DRAINAGE INFORMATION SHEET

PROJECT TITLE: Colby Plaza ZONE ATLAS/DRNG. FILE #: K-14/D40
 LEGAL DESCRIPTION: Lots U, V, W, X & Y, Ambrosia Parcel Addn.
 CITY ADDRESS: 3rd St between Ogden & Ogden
 ENGINEERING FIRM: Bahannon - Heston Inc CONTACT: Kerry Heston
 ADDRESS: 7500 Jefferson NE PHONE: 825-1000
 OWNER: Beta West Prop. Inc CONTACT: Gary Unazio
 ADDRESS: 1999 Broadway Suite 2000 PHONE: 303-592-7099
 ARCHITECT: _____ CONTACT: _____
 ADDRESS: _____ PHONE: _____
 SURVEYOR: _____ CONTACT: _____
 ADDRESS: _____ PHONE: _____
 CONTRACTOR: _____ CONTACT: _____
 ADDRESS: _____ PHONE: _____

RE: DRAINAGE PLAN FOR BETAWEST - ALBUQUERQUE PLAZA
RECEIVED MARCH 10, 1989 DATED MARCH 7, 1989 (K-14/D40)

CONCEPTUAL DRAINAGE / GRADING PLAN

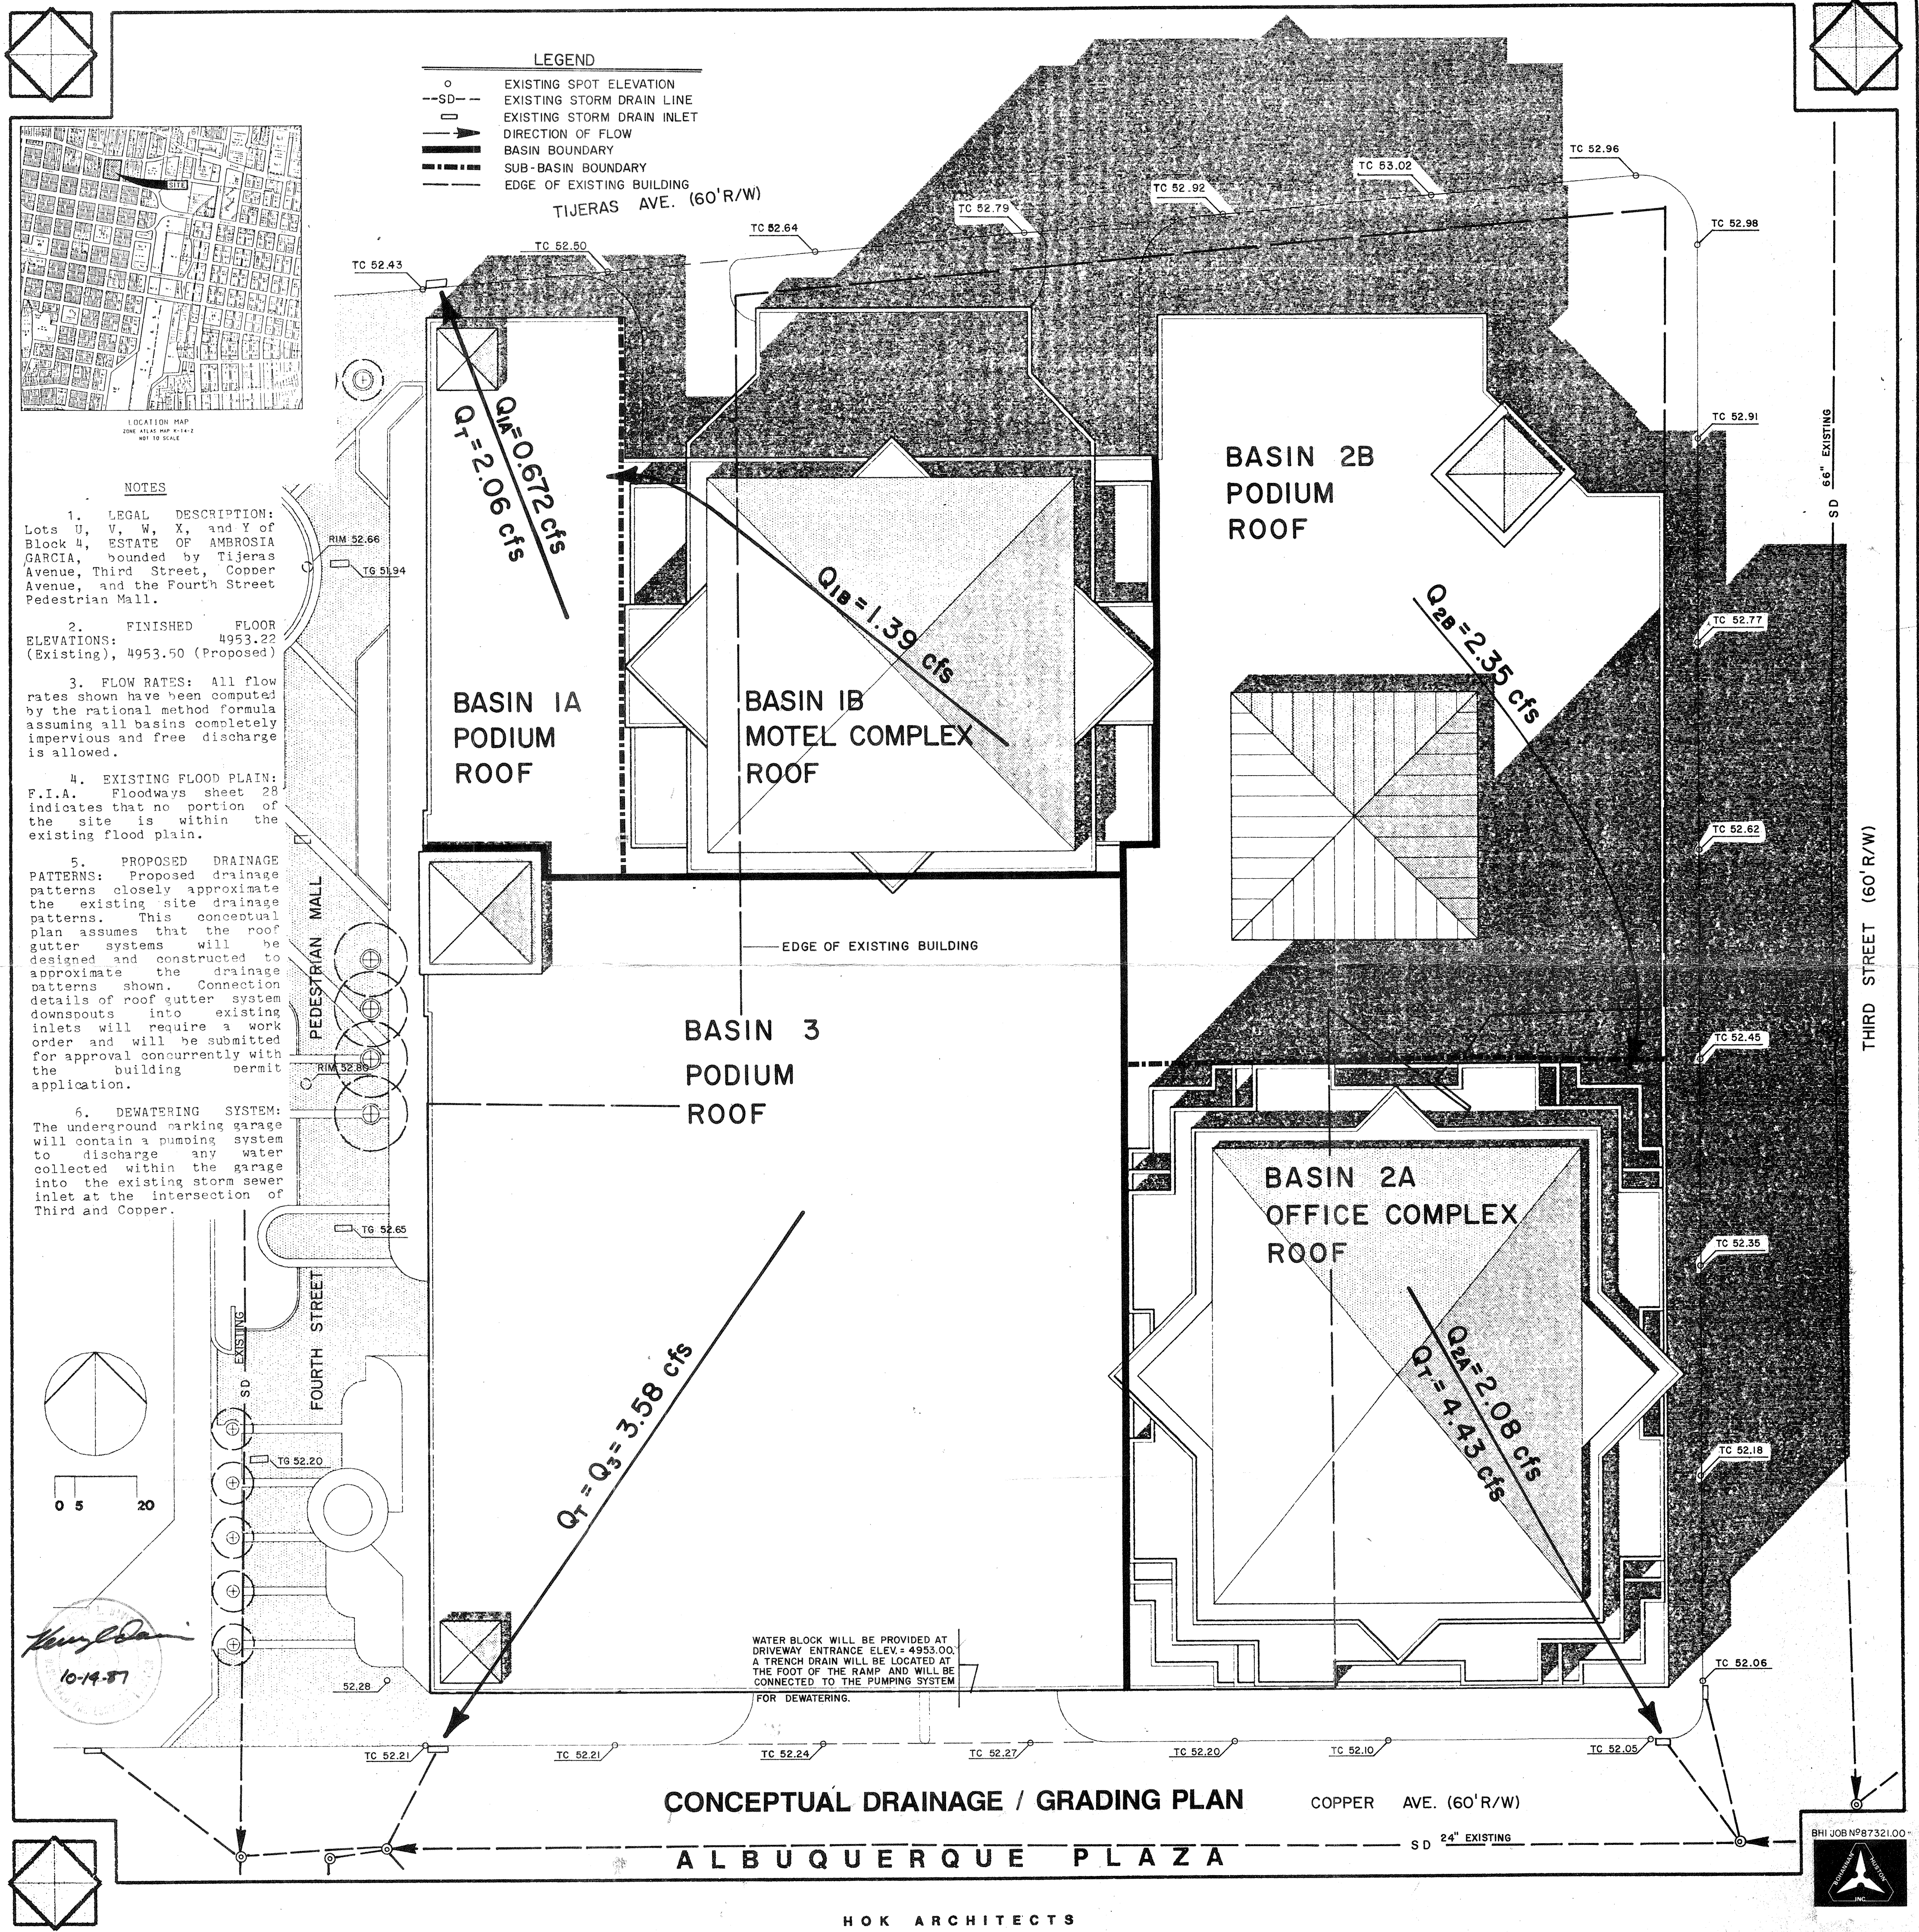
The above referenced plan, dated October 14, 1987, is approved for Site Plan approval.

Prior to Building Permit release by Hydrology, a more detailed drainage plan will be required for approval. The Work Order needs to be submitted to DRC for their review and comment.
